# UNITED STATES PATENT AND TRADEMARK OFFICE

APPLICATION NO.	FILING DATE	FIRST NAMED INVENTOR	ATTORNEY DOCKET NO.	CONFIRMATION NO.
10/501,423	07/13/2004	Johannes Jacobus Franciscus Geijtenbeek	NL 020024	9929
24737	7590	01/23/2006	EXAMINER	
PHILIPS INTELLECTUAL PROPERTY & STANDARDS			HO, BINH VAN	
P.O. BOX 3001			ART UNIT	
BRIARCLIFF MANOR, NY 10510			PAPER NUMBER	
			2821

<b>Office Action Summary</b>	Application No.	Applicant(s)	
	10/501,423	GEIJTENBEEK ET AL.	
	Examiner	Art Unit	
	Binh V. Ho	2821

## **DETAILED ACTION**

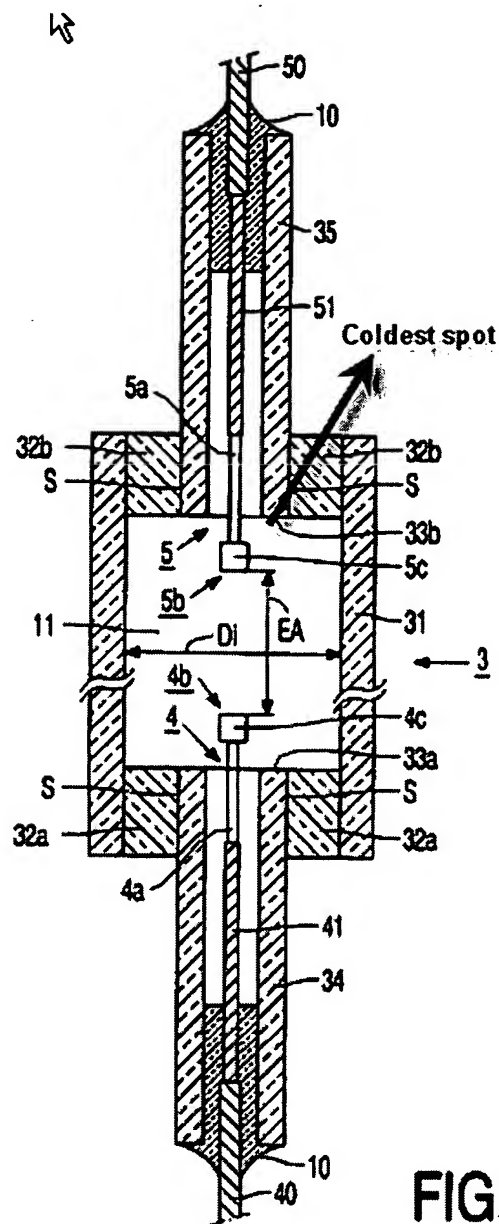
(Claim 2)

Geijtenbeek discloses in figure below, the coldest spot being close to the top of the discharge chamber (coldest spot which is the top of the chamber is inherently the farthest distance from the electrode because it conducts and absorb the least heat generated from radiation).

FIG. 1

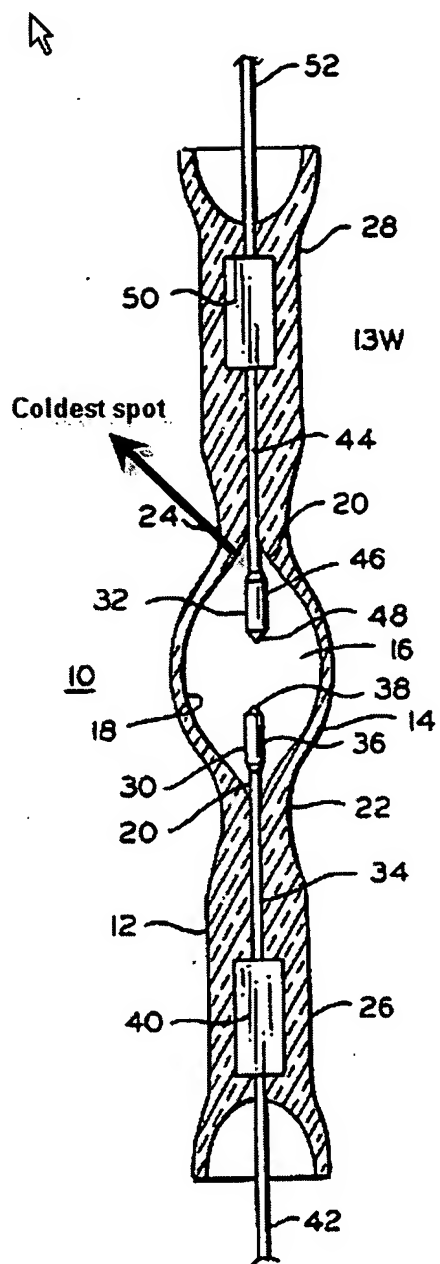
(Claim 2)

Graham discloses in figure below, the coldest spot being close to the top of the discharge chamber (coldest spot which is the top of the chamber is inherently the farthest distance from the electrode because it conducts and absorb the least heat generated from radiation).
